STAFF REPORT

PLANNING & ZONING COMMISSION

Wednesday, March 8, 2017

2. FINAL DEVELOPMENT PLAN REVIEW

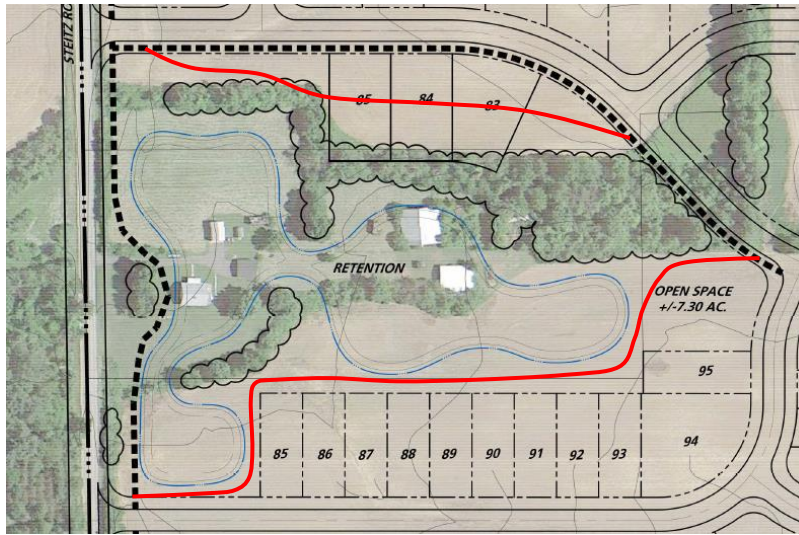
1. Remove lots 83, 84, and 85 from the northern main entrance road. This would increase the amount of open space and takes out lots that seem out of place. Furthermore, it would reduce the density of the project from 1.81 du/ac (dwelling units per acre) to 1.77 du/ac, which is more in line with the 1.7 du/ac maximum that staff feels is appropriate for this area of the city.

2. Have the multi-use paths go through the above open space area instead of at the edges. This would provide a loop trail that residents could use. Also, it improves safety, by taking the trail from the along the road to an interior space. Essentially, separating the pedestrian from the vehicle.

Presidential Point – Secondary Joint Identification Sign

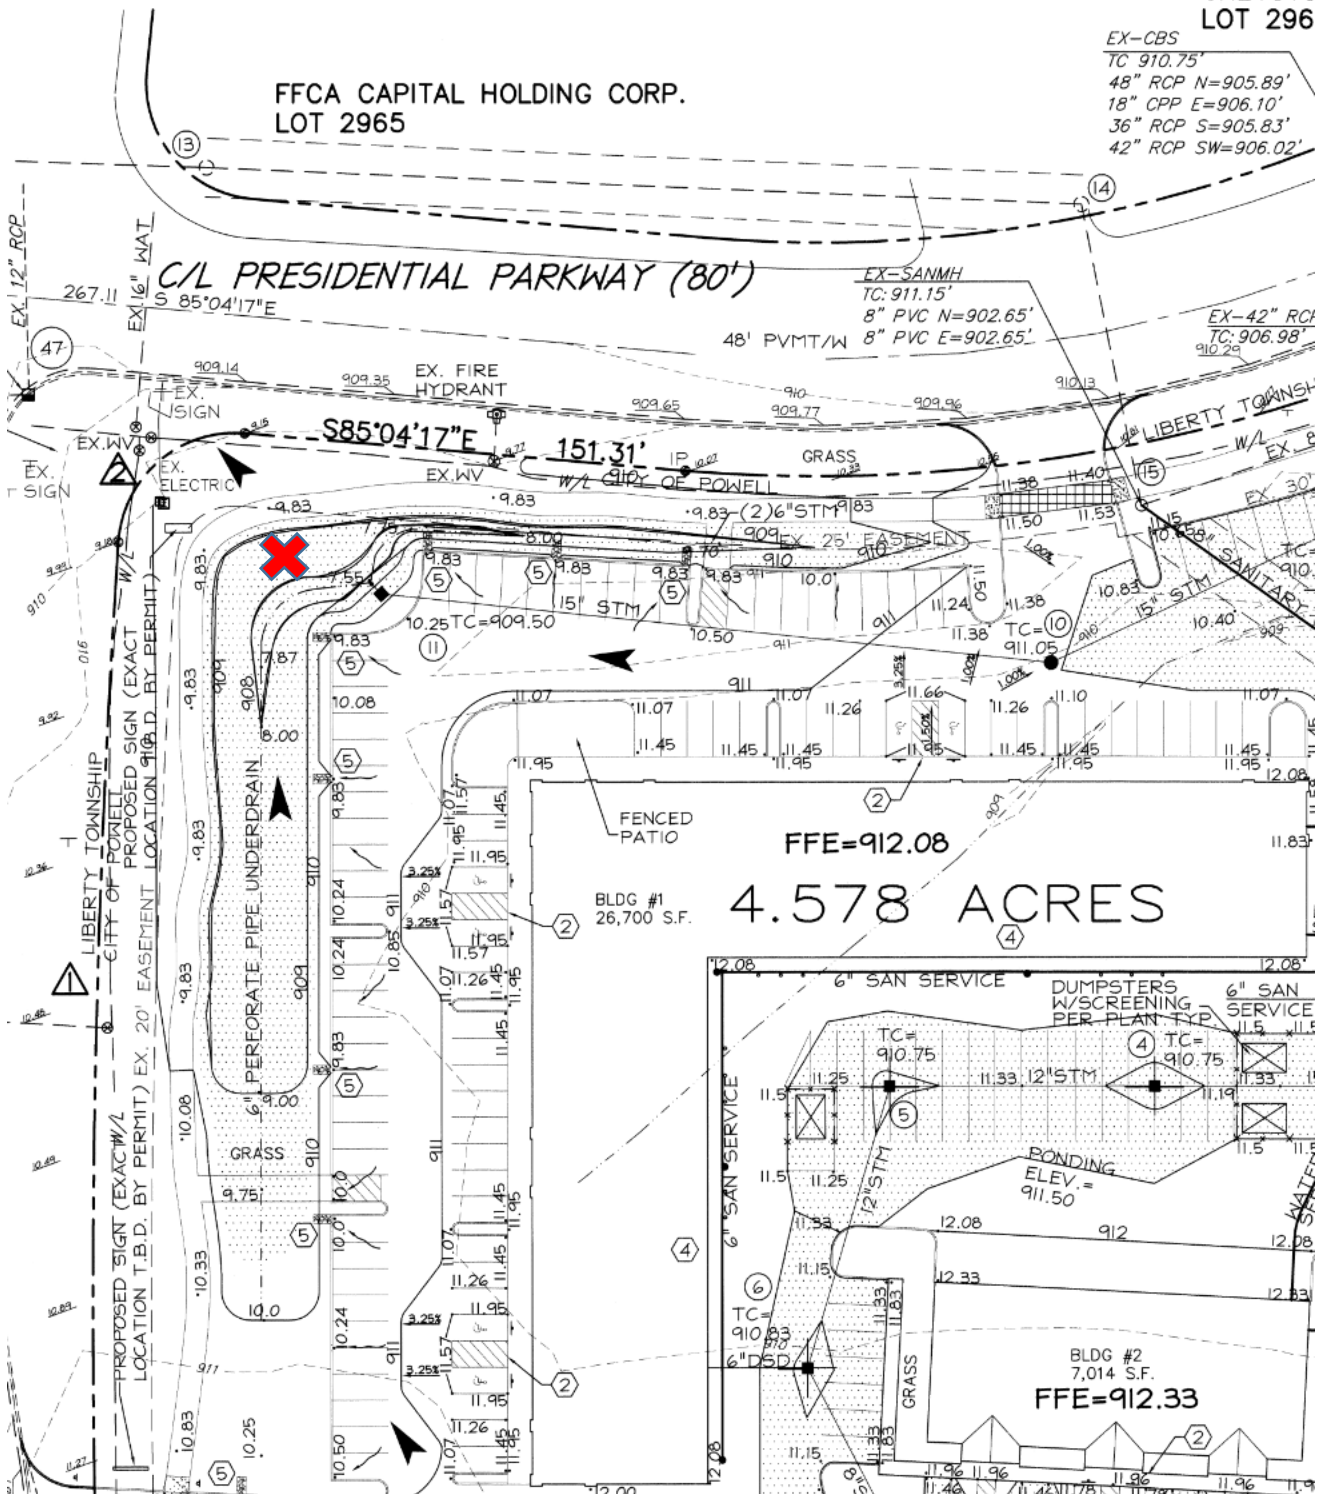
The sign is a total of 152 square feet per side. Our code allows for multiple tenant signs as follows:

Joint identification signs. On lots less than ten acres, primary joint identification signs may not exceed 56 square feet in area or be more than eight feet in height. Secondary joint identification signs shall not exceed 36 square feet in area or be more than eight feet in height. On lots ten acres or greater primary joint identification signs may not exceed 72 square feet in area or be more than ten feet in height and secondary joint identification signs may not exceed 48 square feet or be more than eight feet in height.

The shopping center site is a total of 4.9 acres, therefore, the maximum size joint identification sign can be 56 square feet in area. A second joint identification sign can be 36 square feet in area. The shopping center has another monument sign at the south entrance:

Staff recommends approval of this proposed sign as adding a third monument joint identification sign would be the only other option and would not address solving the problem for tenants having visibility from this sign on Sawmill Parkway. The proposed sign with the change in color will differentiate itself from the other shopping center sign and be farther back as Staff has proposed. The City Engineer also agrees that the proposed sign should be setback even further. The following conditions should be added to any approval:
